APPLICATION NUMBER: RECON 24/0467

PROPOSAL: RESERVED MATTERS APPLICATION FOR SPORTS PITCHES, CHANGING FACILITIES AND ALLOTMENTS, ASSOCIATED INFRASTRUCTURE AND LANDSCAPING PURSUANT TO OUTLINE PLANNING PERMISSION 16/0864

SITE: Llanwern Village Development Site Phase 1 Cot Hill Llanwern Newport NP18 2DP

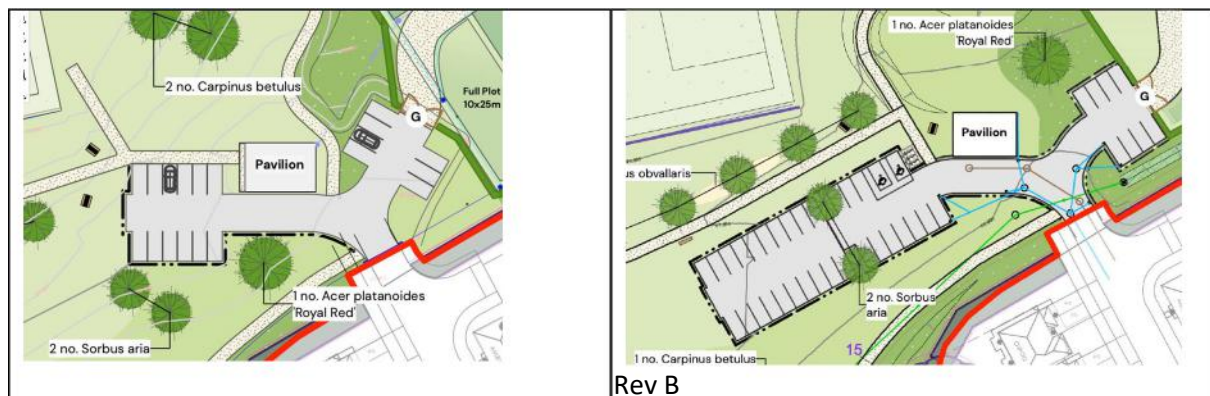
3. The key landscape plan is 'Sports park & northern public open space' soft landscape plan by Pegasus, revised to rev B – see extract below. My previous comment on the lack of planting to soften or enclose the car parking, pavilion building, and site entrance has been responded to by adding 2 no trees. In my view this is inadequate and will not help to create a welcoming and human-scale landscape. In addition, the main car park has been extended significantly from the original but there is no additional planting to soften views for park users or for

overlooking properties. A more detailed planting scheme by Pegasus is needed for what will be the central hub of the wider park. – **Can be secured via an appropriately worded condition**
